Landscape and Visual Response
In respect of a Request for Further Information (RFI)
Ballinrooaun Quarry Extension Development
By Macro Works, February 2018

1.1 RFI Item 12:

Figure 1.0 Viewpoint location map for RFI Item 12

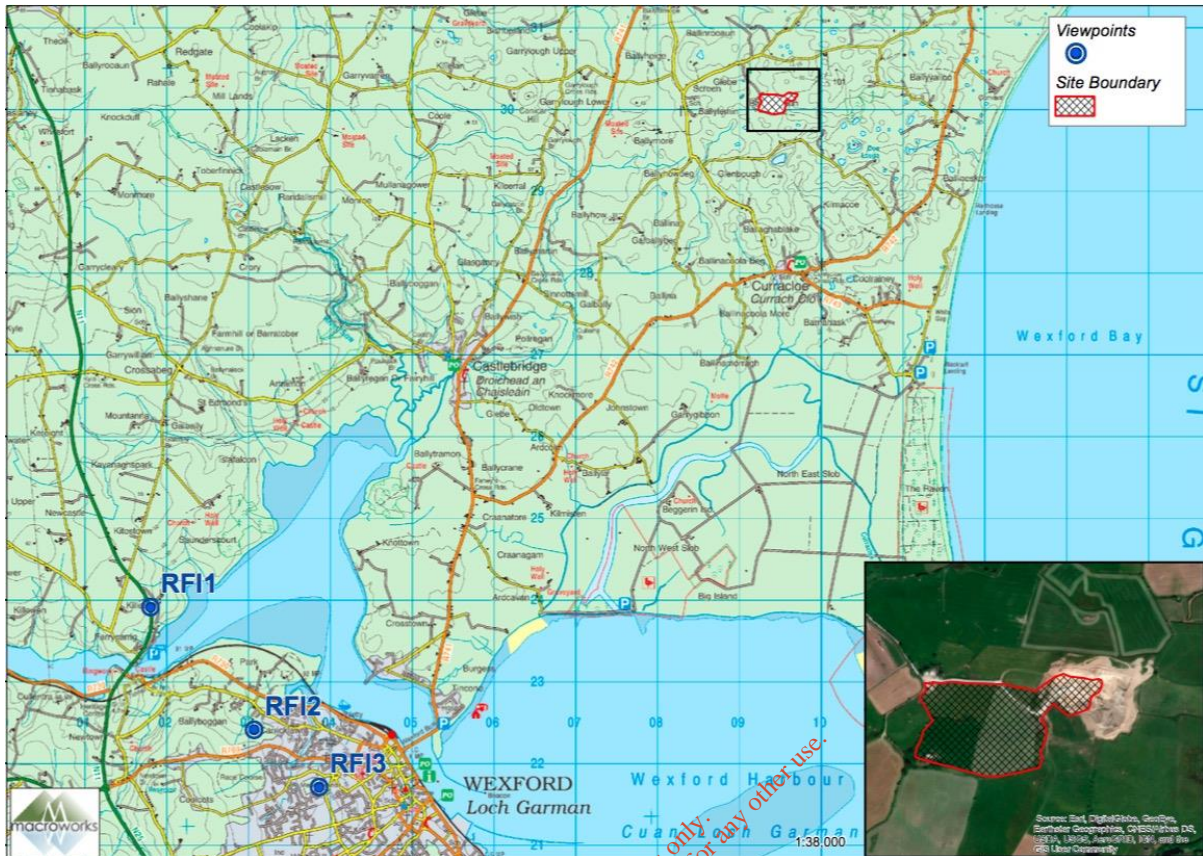
“As the southern side of Ballinrooaun terrain and feature is virtually unspoiled and is visible from a wide landscape area including Wexford Town itself the applicant is requested to submit additional views and photomontages of the proposed development at extraction phase from distances further south from public view points such as Wexford racecourse or other elevated land within Wexford Town and near the Ferrycarrig Bridge.”

From similar studies it was anticipated that the proposed Development was likely to be difficult to discern beyond approximately 5km and would be unlikely to give rise to significant landscape or visual impacts beyond approximately 2km. Wexford Town and Ferrycarrig Bridge, however, is a distance of 9-11km southwest of the Application Site. In accordance with the RFI Item 12 request, in February 2018 three additional viewpoints were captured within Wexford Town and near Ferrycarrig Bridge, as indicated in Figure 1.0 below.
